Project Title: CHUCK E. CHEESE'S

Plan Check #: 99-03337

SAN JOSE FIRE DEPARTMENT PLAN CHECK COMMENTS

Re: Plan Review: CHUCK E. CHEESE'S

DETAIL

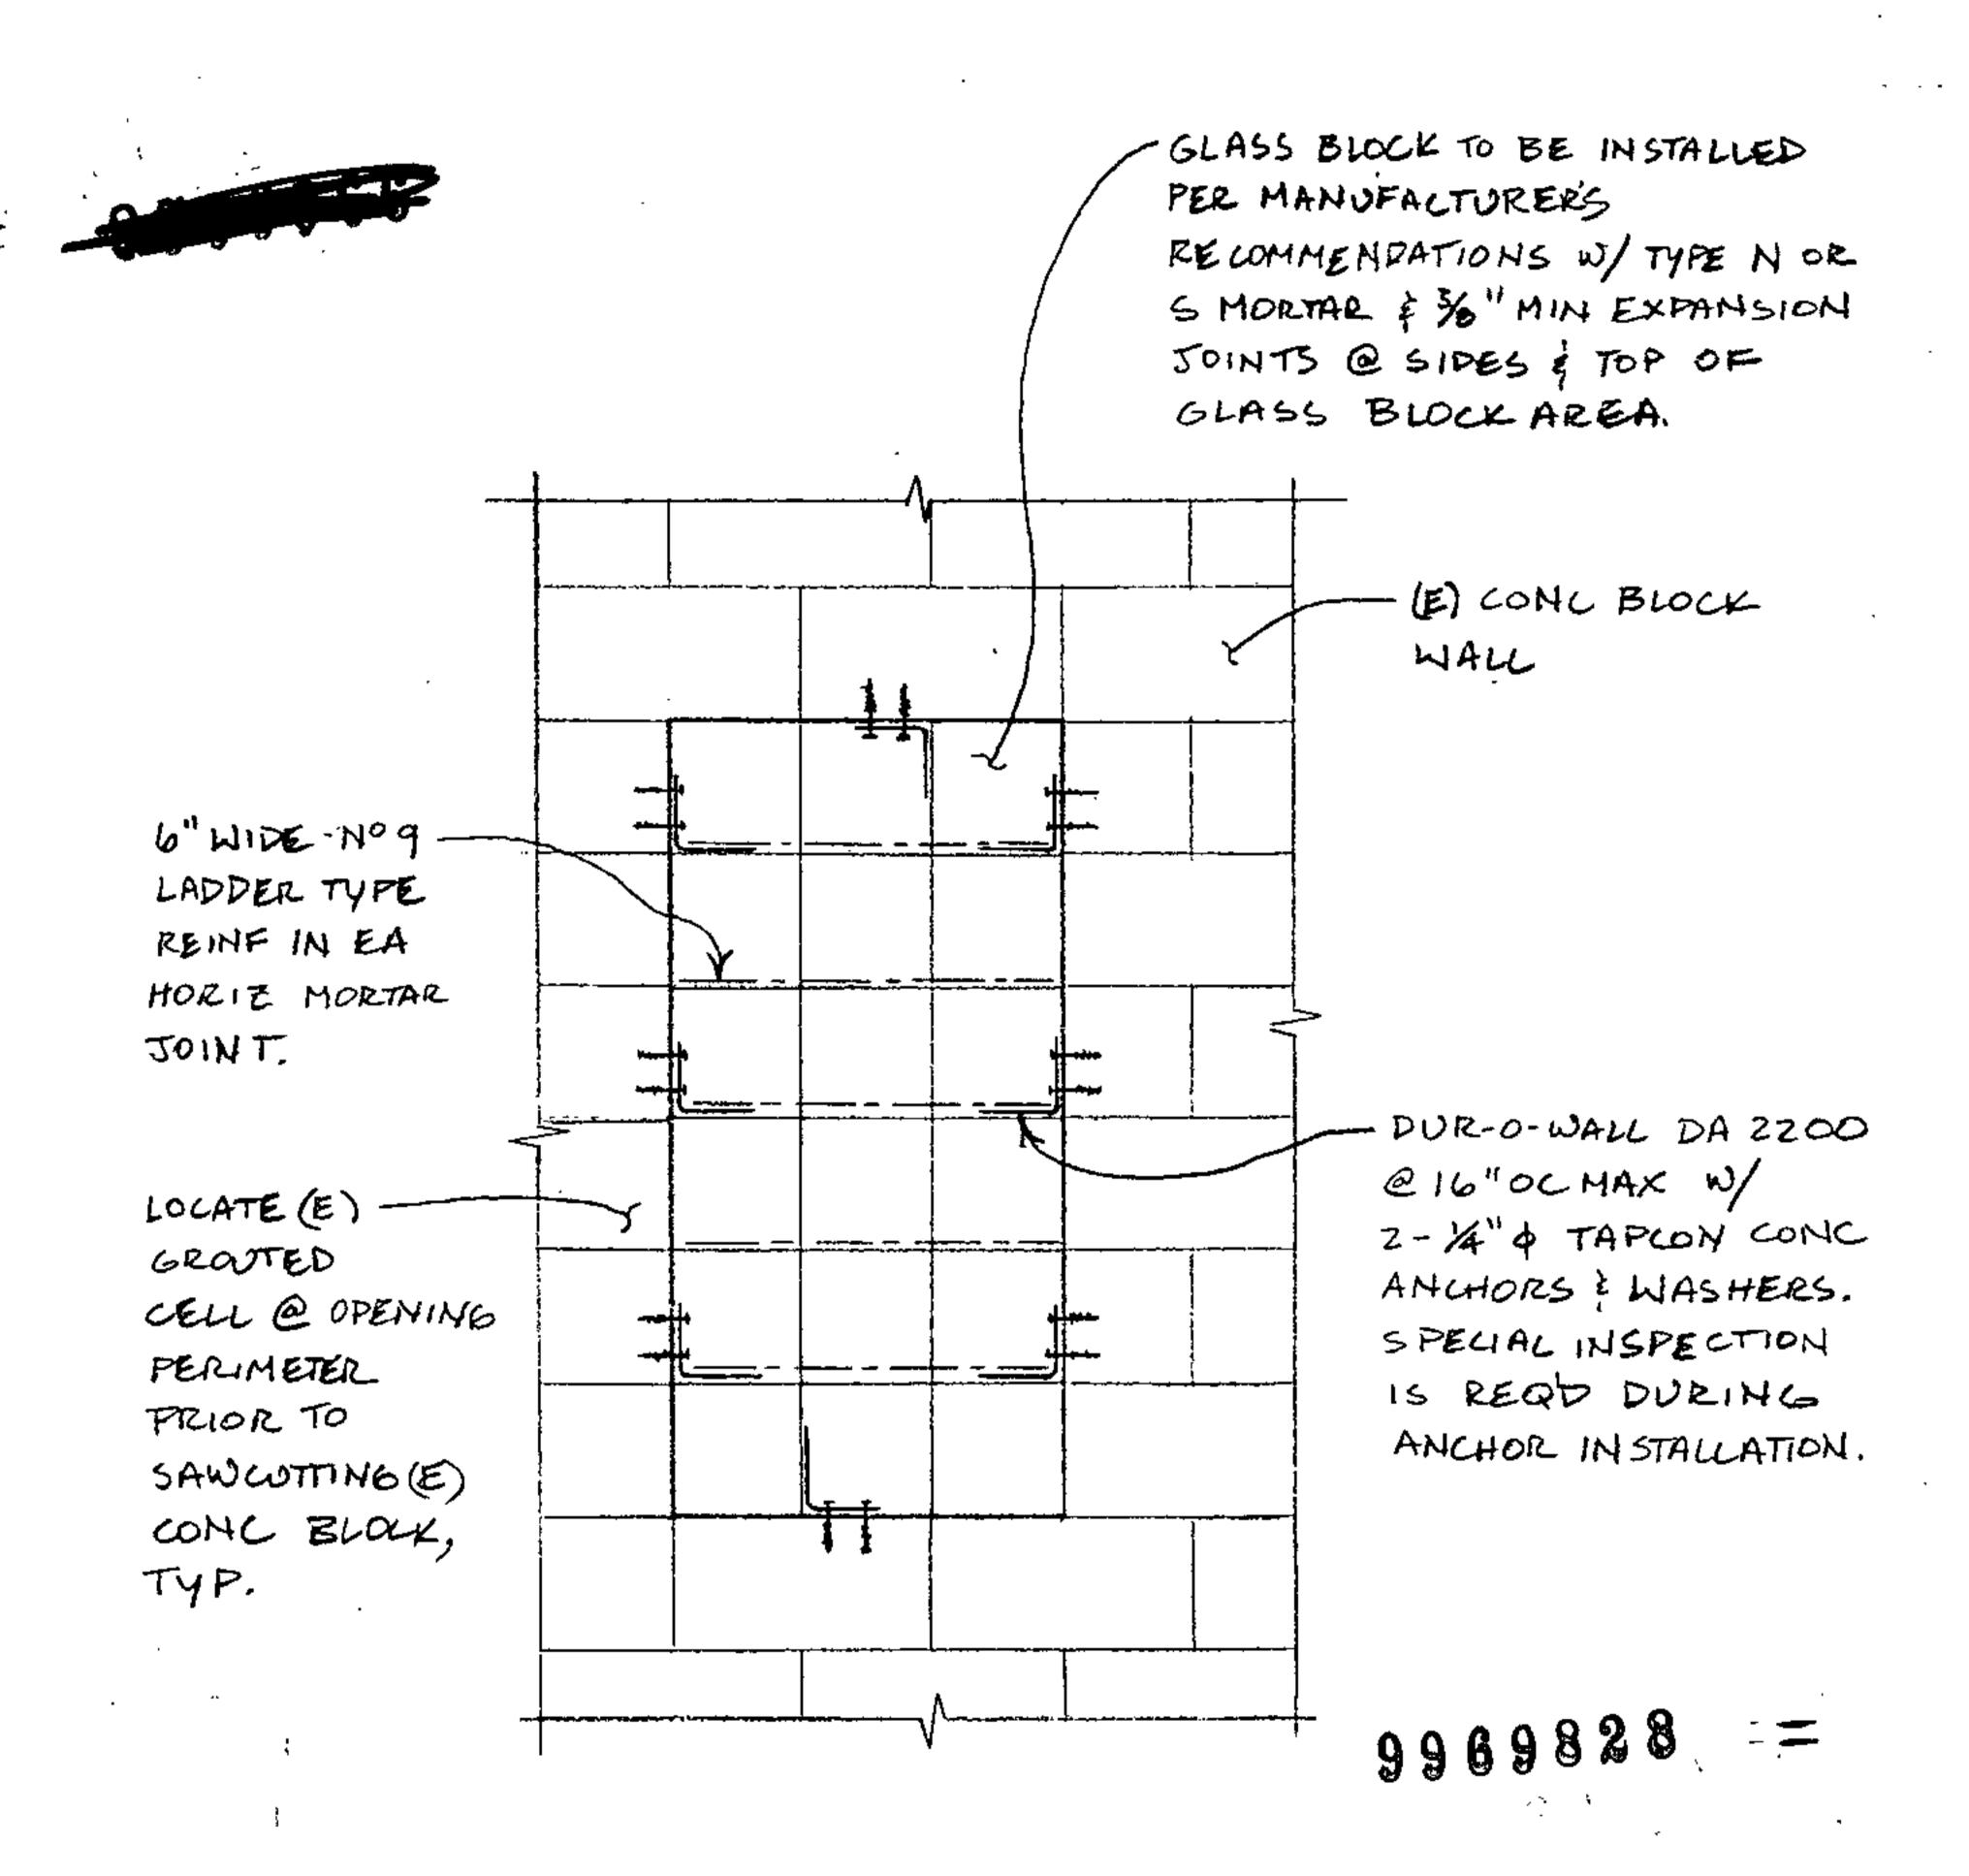
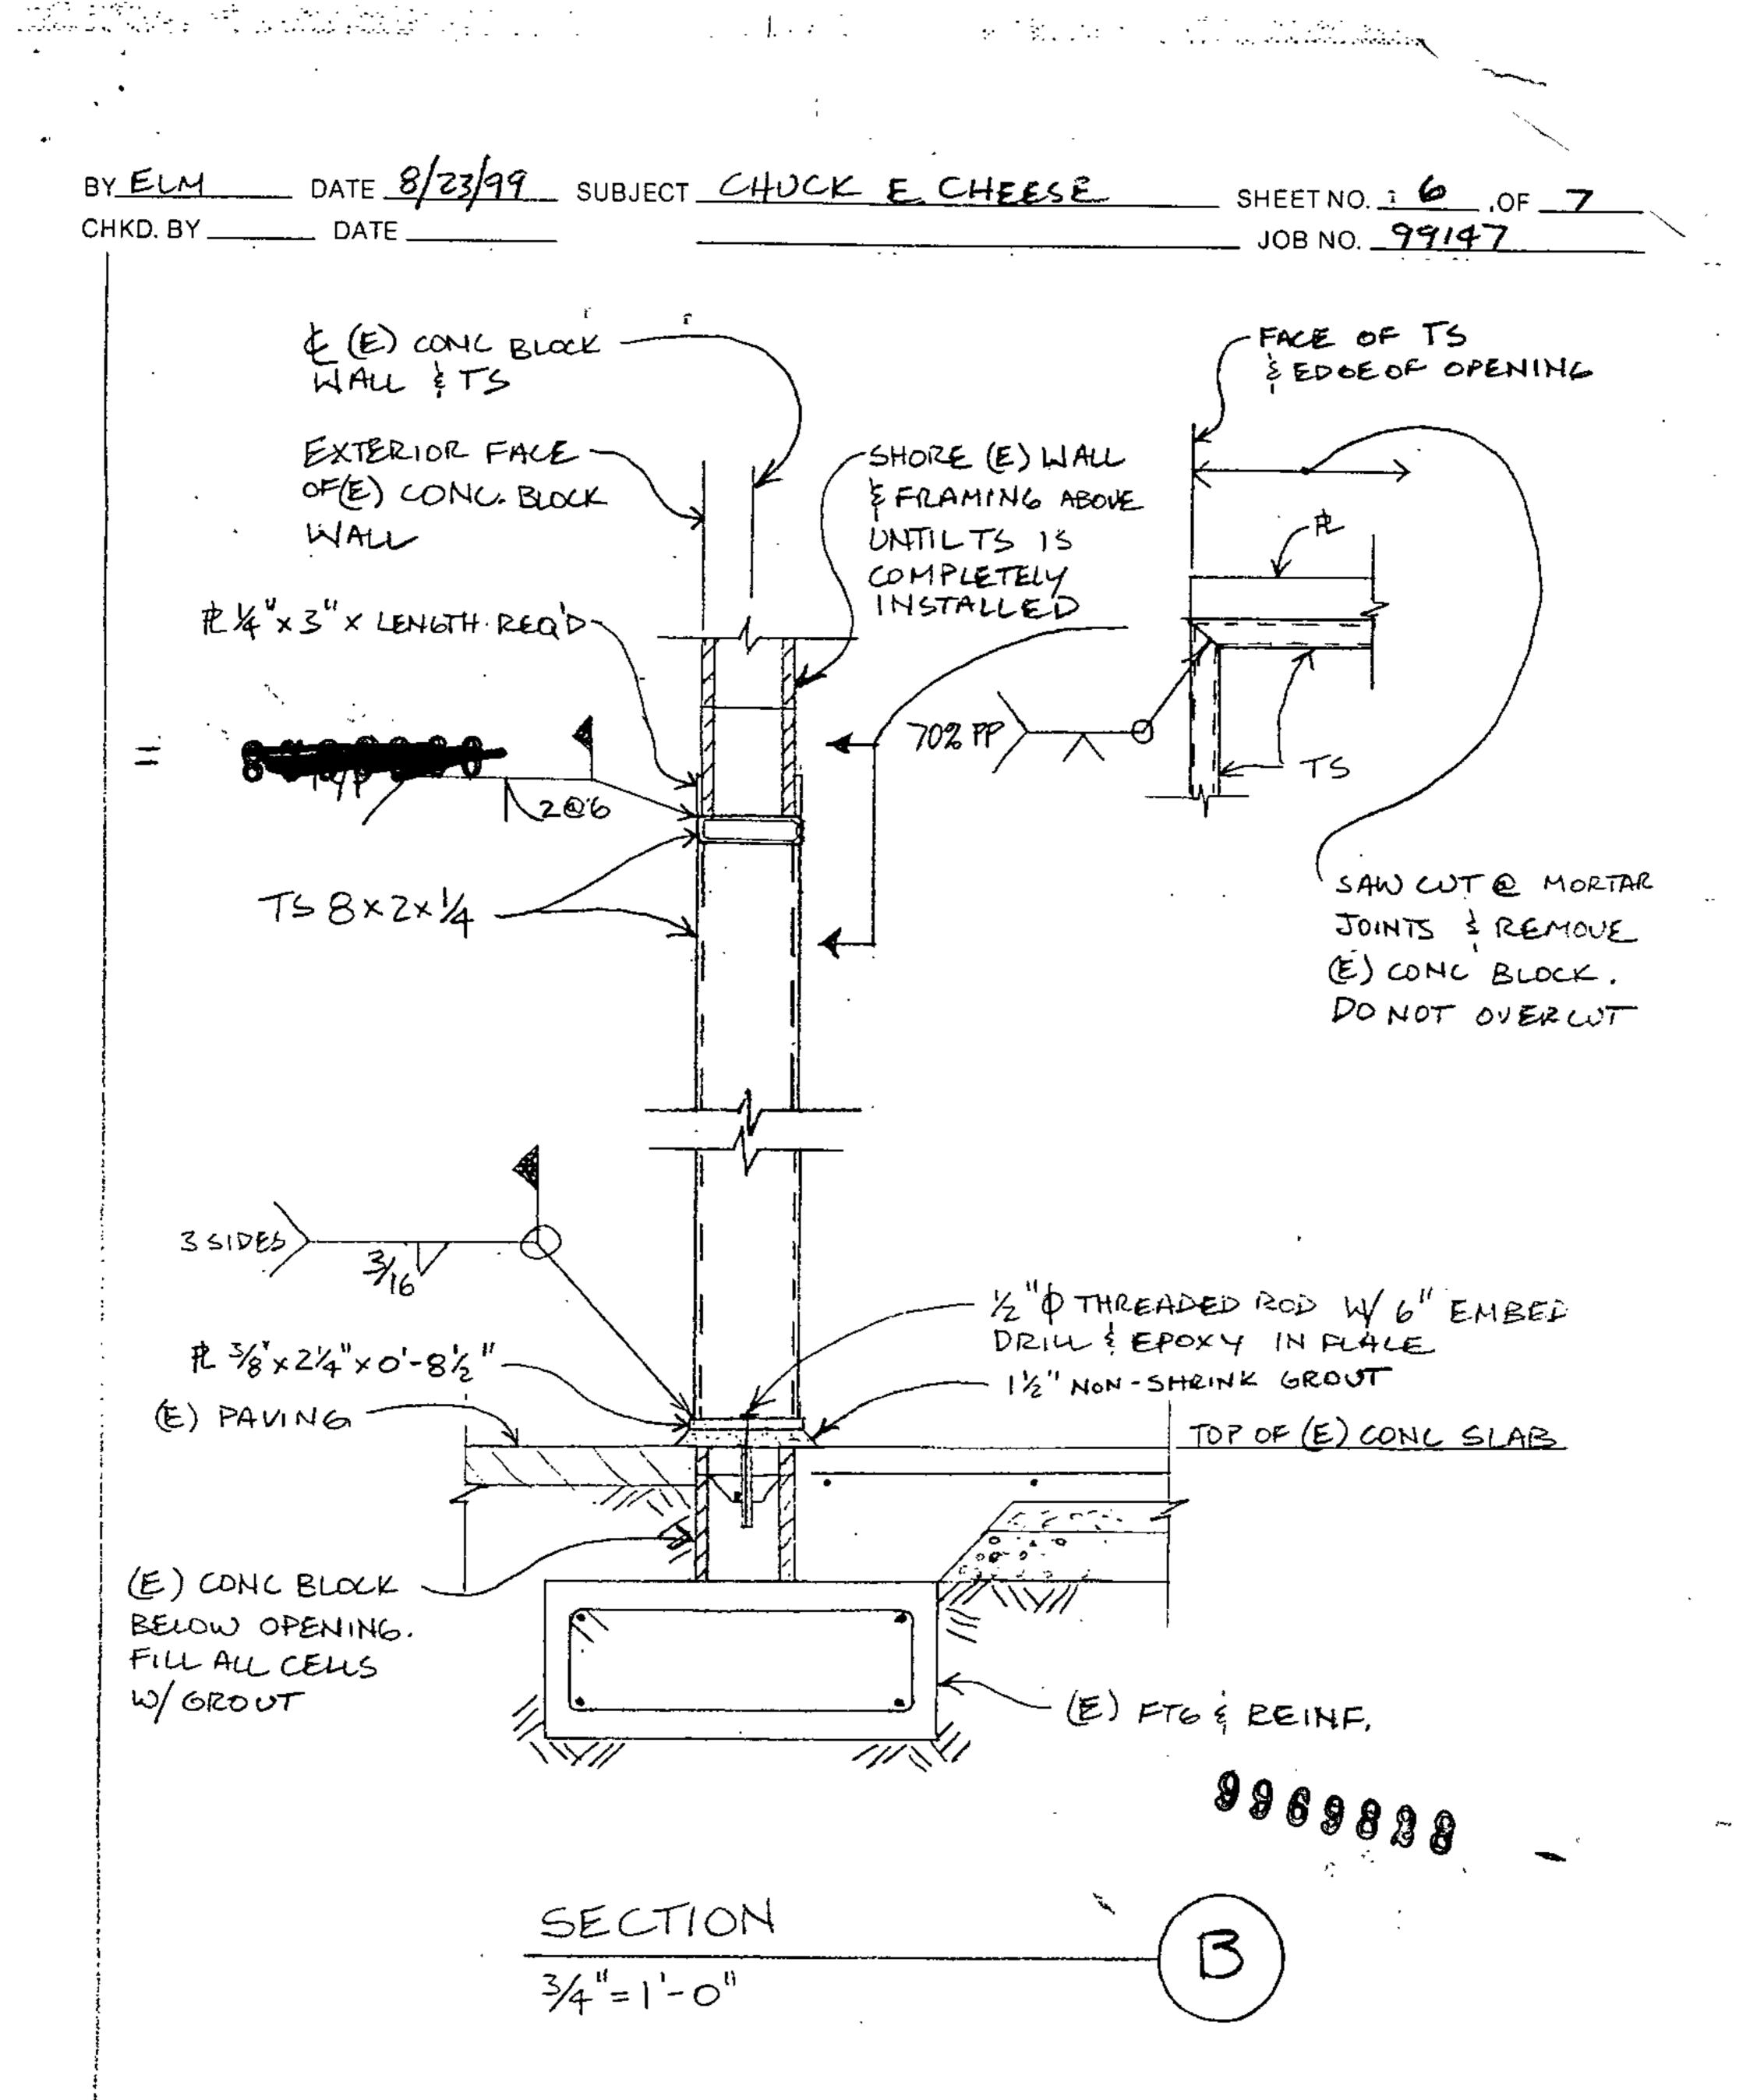
- 1. Provide details of the glass masonry to be installed at the new openings. Details of the glass block construction shall include the reinforcing and the expansion and mortar joints. Section 2110
- 2. Provide details and dimensions for the new canopy over the entry.
- 3. Provide structural details and calculations at new exterior door openings. Evaluate the capacity of the remaining shear walls. Detail all pertinent items to be field verified.
- 4. Provide structural details for fill in door openings.

- See attached detail A.
- The canopy over the entry will be a differed submittal.
- See attached detail B and Supplemental Structural calculation #1.
- See attached section C.
